Great North Road Solar and Biodiversity Park

Final Statement of Common Ground with National Highways

Document Reference – EN010162/APP/8.4D

April 2026

Project:
AADT CONSTRUCTION TRAFFIC FLOWS ON A1
WORST CASE (100% Route North AND 100% Route South)

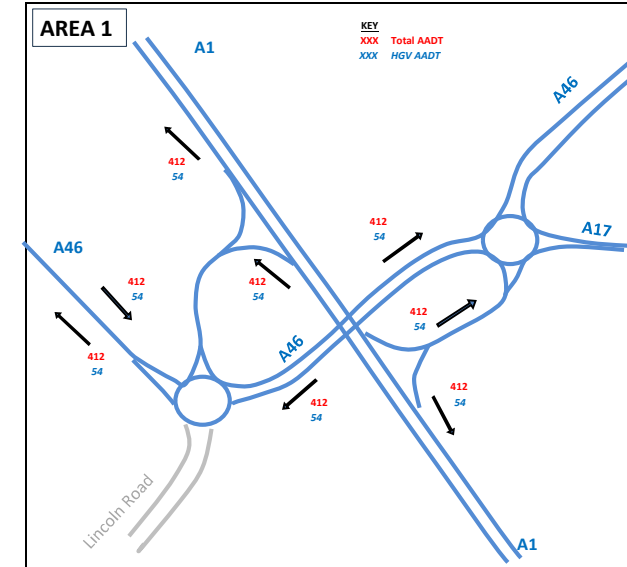
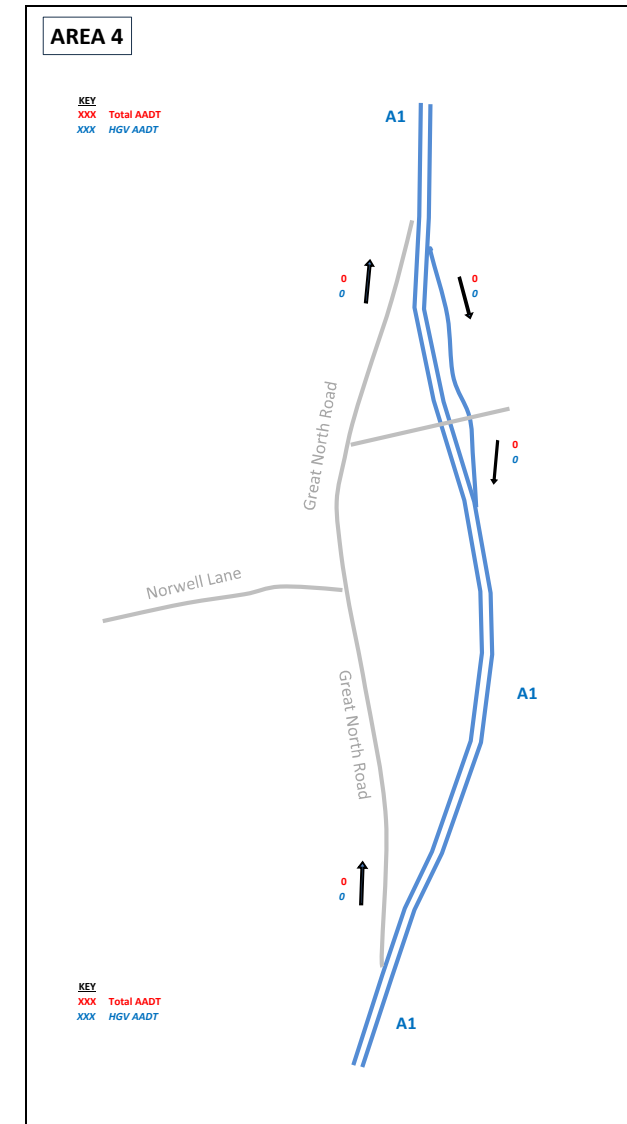
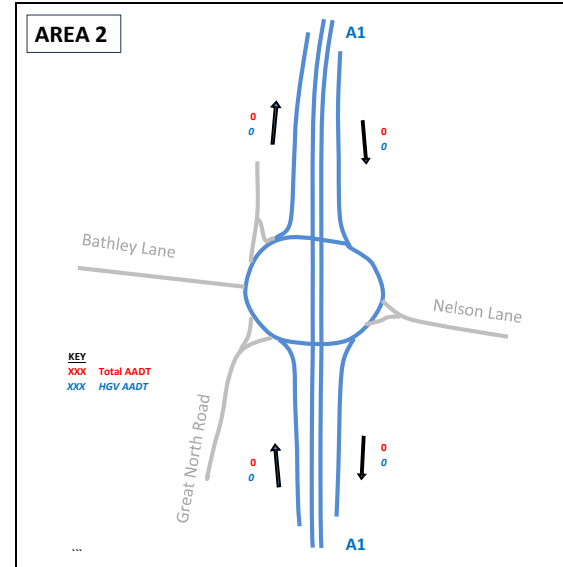
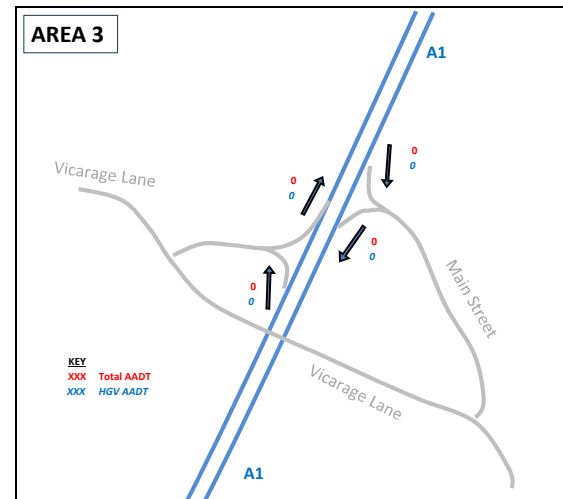
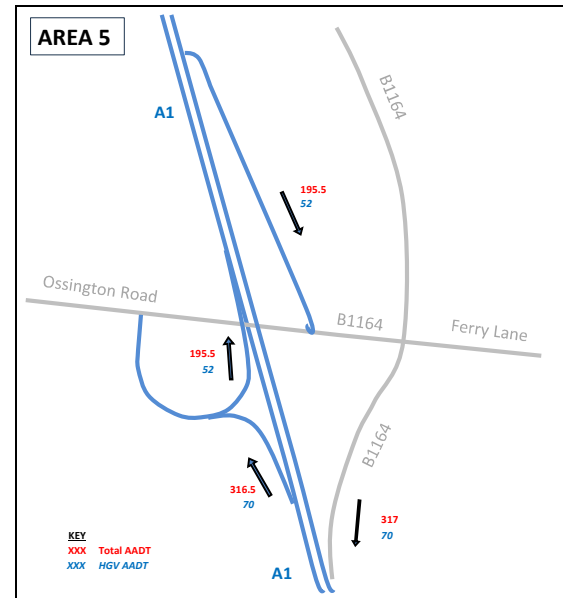
Month																									1	2	3	4	5	6	7	8	9	10	11	12	13	14	15	16	17	18	19	20	21	Trips on A1	0	12	20	26	6	10	10	11	11	11	7	4	1	16	28	36	8	12	13	13	13	
	Month																																																																									
	1	2	3	4	5	6	7	8	9	10	11	12	13	14	15	16	17	18	19	20	21																																																					
Trips on A1	0	12	20	26	6	10	10	11	11	11	7	4	1	16	28	36	8	12	13	13	13																																																					
2.1.5	WR	Trip Distribution	NH has reviewed the further information provided by the Applicant and is now content that the trip distribution is agreed. The additional information provided in the	Traffic flow diagrams for the junctions on the A1 were provided at Deadline 1. The flows presented are the AADT construction traffic flows on the A1, assuming a scenario whereby all traffic routes to/from the north and also, all traffic routes to/from the south. These diagrams	Agreed

revised ES Chapter alongside the traffic flow diagrams provided at Deadline 1 provides clarity on the development proposals impact on the A1 and are deemed acceptable by NH.	will show the traffic flows currently presented in Appendix 1 of this SoCG.
